DEVIATION FOR APPROVAL

Deviation to approved plan 22020085 on dwelling ERF 1237, 6 Adelaide Tambo Drive, Durban North

SITE PLAN

SITE PLAN | 1:100 @ A0

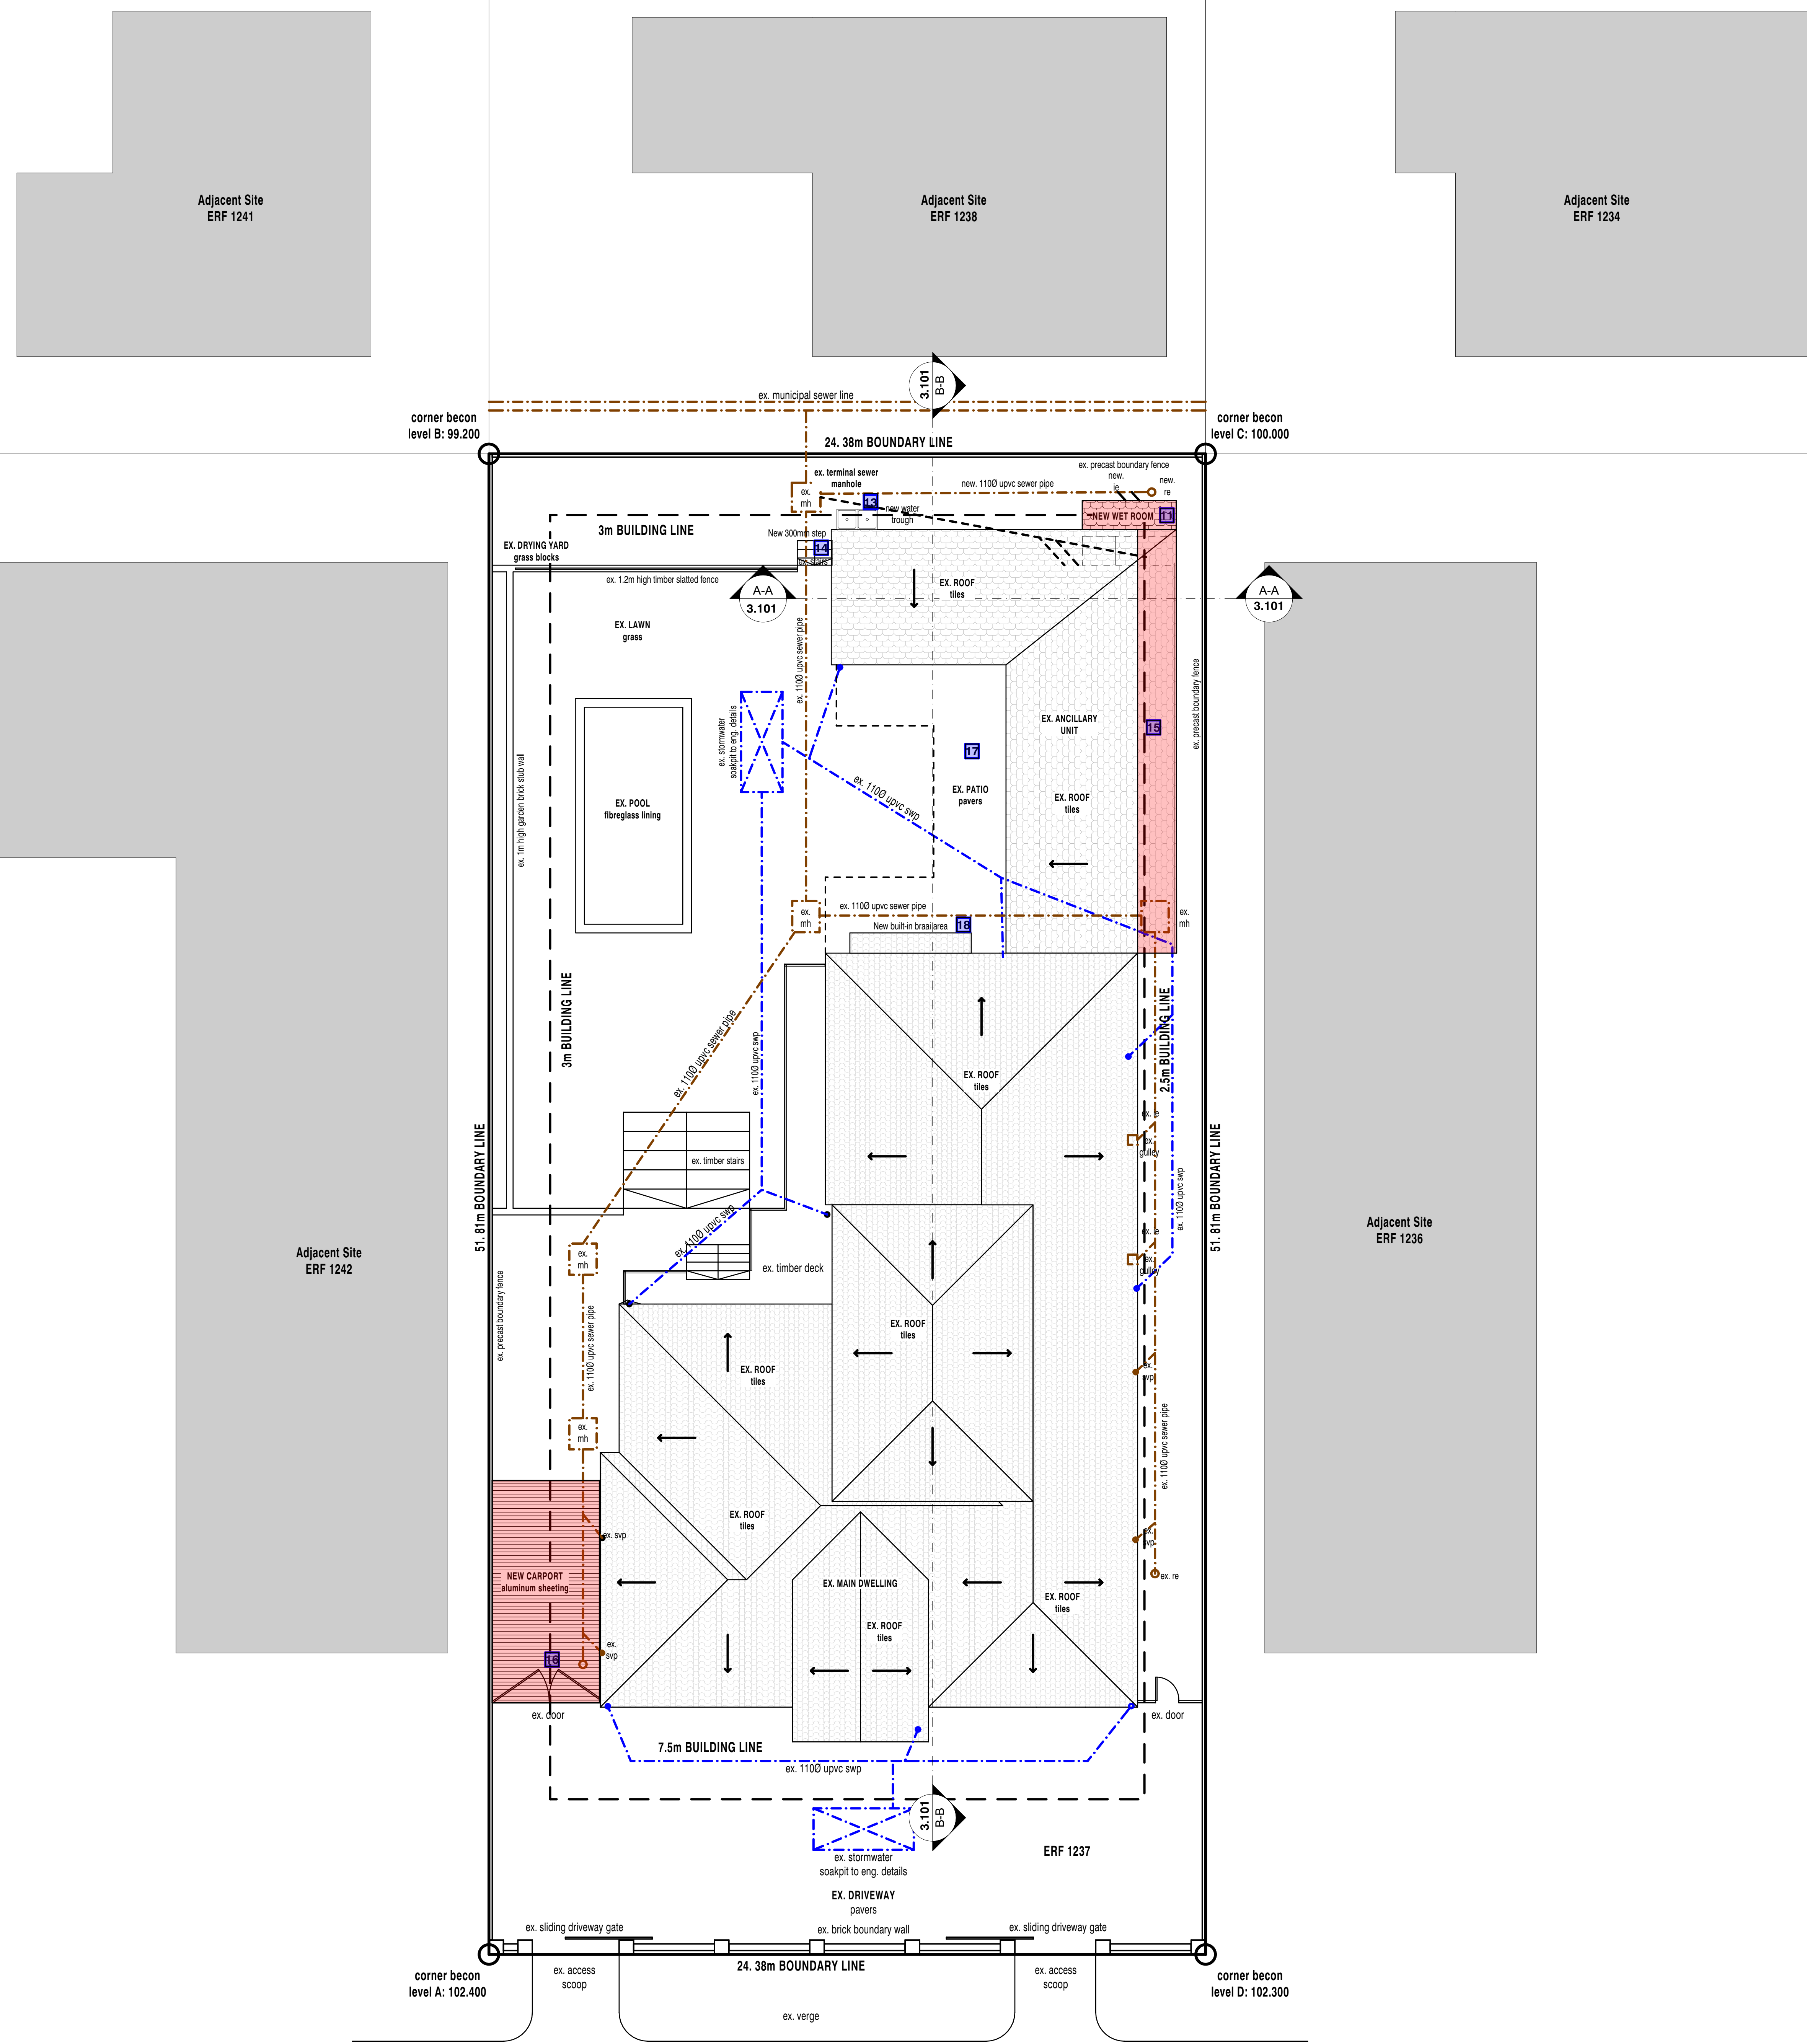
1. Door Replaced
2. Door Revised
3. Window Omitted and opening bricked up
4. Kitchen Demolished
5. New Extended Bathroom
6. New Carport
7. Door Omitted
8. Window Revised
9. New Door
10. New Window
11. New Wet Room
12. Stairs like revised
13. New Water Trough
14. Steps revised
15. Ex Ancillary Unit converted to form part of the house
16. Change in Areas
17. Aving Omitted
18. New Built in Braai Area
